Point Beach Nuclear Plant, Units 1 and 2
Dockets 50-266 and 50-301
Renewed License Nos. DPR-24 and DPR-27

License Amendment Request 241
Alternate Source Term
Response to Clarification Request

LICENSE AMENDMENT REQUEST 241 ALTERNATE SOURCE TERM RESPONSE TO CLARIFICATION REQUEST

Figure 2: Activity Transport Path from Unit 2 Residual Heat Removal Area to Facade

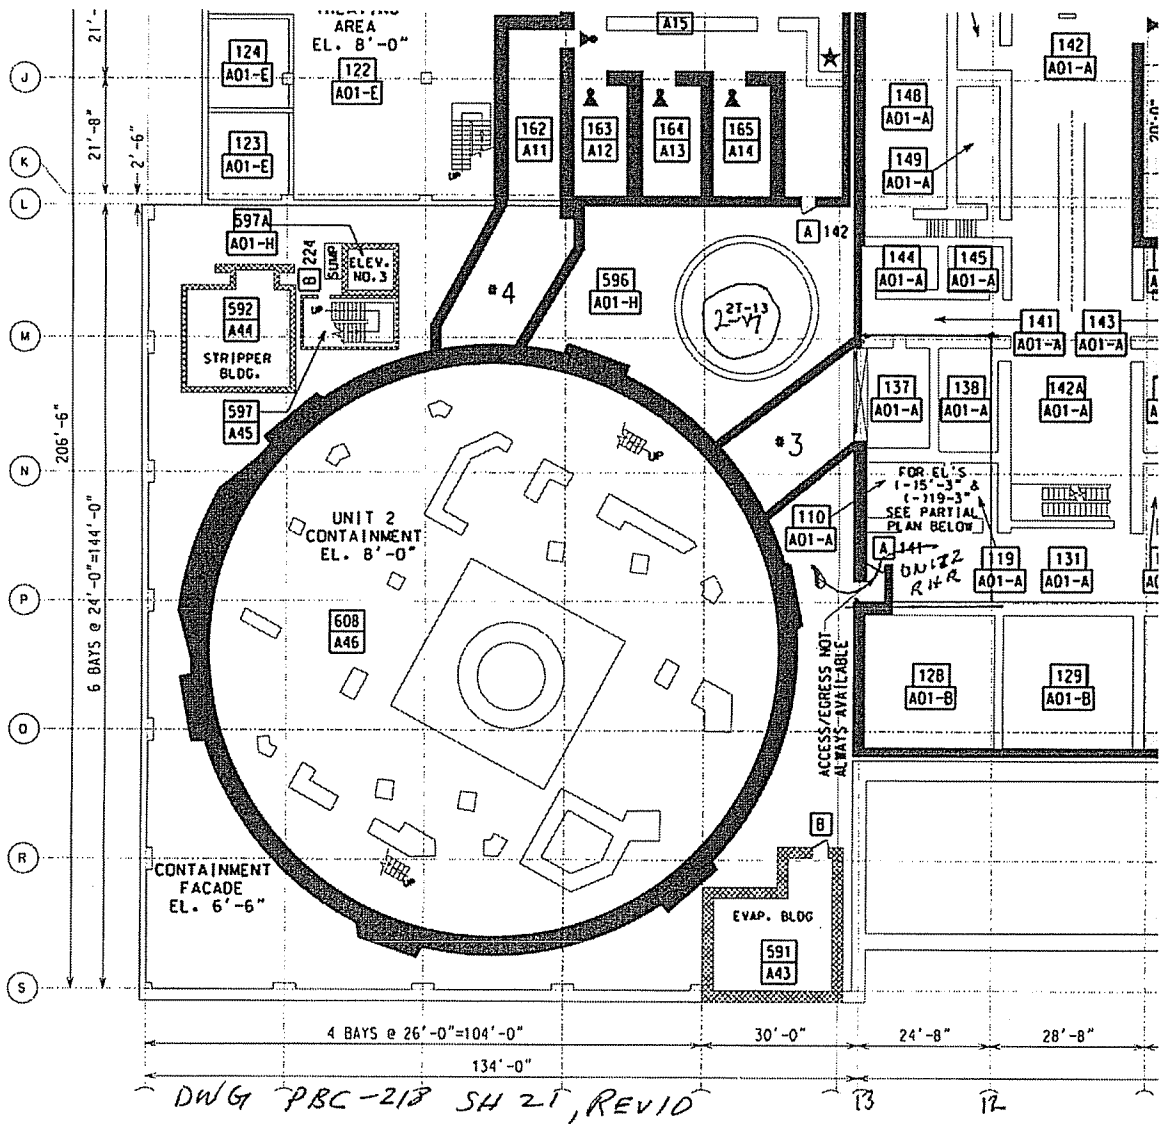
Provide a figure showing the release points.

Discuss the selection of the release points versus other release points that were not selected.

Figure 1 in Enclosure 3 provides a plan view of the release location and control room (CR) air intake. The RHR pumps are located on El. -19' 3". Other RHR equipment is located on El. -5' 3" and El. 8'. A doorway is located on El. 8' (See Figure 2 in Enclosure 3) which leads directly into the containment facade area. To reach the 2-V7 release location, activity released from El. 8' passes directly to the facade. Activity inside the facade travels through the open space and out through the facade roof vent to the environment.
